PRESSURE GAUGE TYPE TESTS - BUDENBERG GAUGE CO. LTD.

A.E.L. TECHNICAL NOTE No. 1731.

PRESSURE GAUGE TYPE TESTS - BUDENBERG GAUGE CO. LTD.

(PHOSPHOR-BRONZE TUBES)

FIG.3. BUDENBERG, 4"(F), 0-600 p.s.i. GAUGE -DIAL INDICATING BENT POINTER AND ZERO ERROR AFTER SHOCK TESTS.

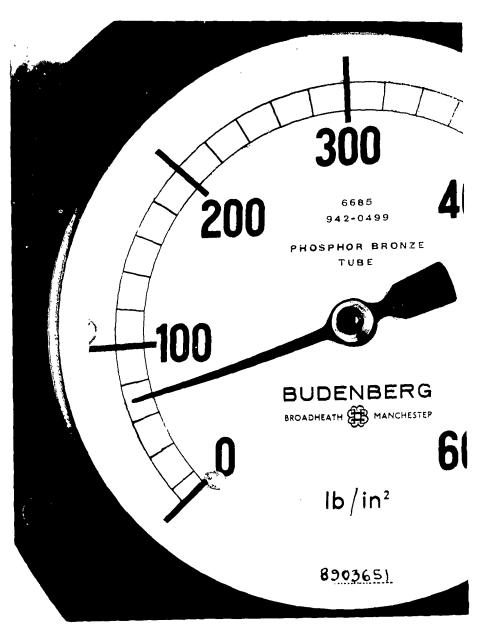
- Pointer Bent Suightly (see Fig. 3.).
47 Drop (Gauge Mounted Horizontally And Dial Facing Upwards. F BACK PLATE EXTRUDED OVER ONE OF ITS SECURING SCREWS (SEE FIG. 4) <u>Polititer on Pinion Hab Not Iocqurred as ear as Ean be iascertained</u> HAIRSPRING DISTORTED TO SOME EXTENT.

BOURDON TUBE END PIECE HAD CONTACTED BACK OF DIAL AND BRASS STOP:

11. The flush mounting, 0-600 p.s.i., gauge failed to meet the specified requirements, in that physical damage occurred during the shock tests. It is recommended that future submissions should not include any fitments restricting free movement of the bourdon tube during testing. Also, if countersunk securing holes are required in the aluminium back plate its thickness should be increased.

BUDENBERG, 4" (F), 0600 p.s. (. GAUGE - VIEW INDICATING DAMAGE TO BACK PLATE DURING SHOCK TESTS.

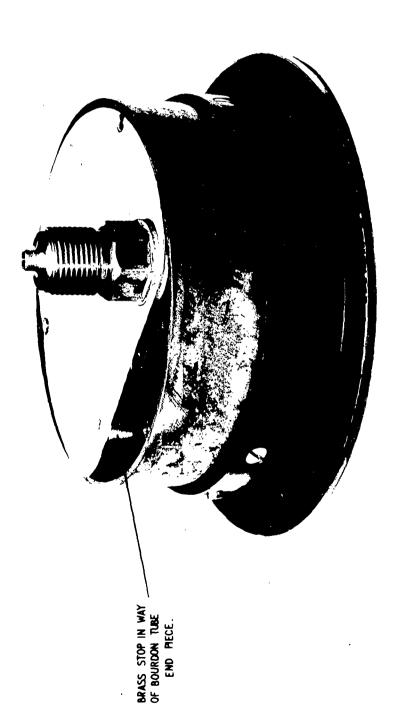
SEE FIG. 3) SECURED TO BACK PLATE IN WAY OF TUBE END PIECE. FORCE ON STOP CAUSED EXTRUSION OF BACK PLATE

GAUGE MEETS THE DIMENSIONAL AND MATERIAL REQUIREMENTS OF adspect tool (al., but the 22 sivis alluminum back plate is:: COMPARATIVELY WEAK AT THE COUNTERSUNK SECURING HOLES. THE BRASS STOP, FITTED PRESUMABLY TO PREVENT FREE MOVEMEN OF TUBE TOWARDS BACK PUATE WHEN UNDER VIBRATION IS CONSIDERED TO BE AN UNDESTRABLE ITEM ALTHOUGH FITTING OF SUCHTIEMS IS nat precuped in the specification 1:
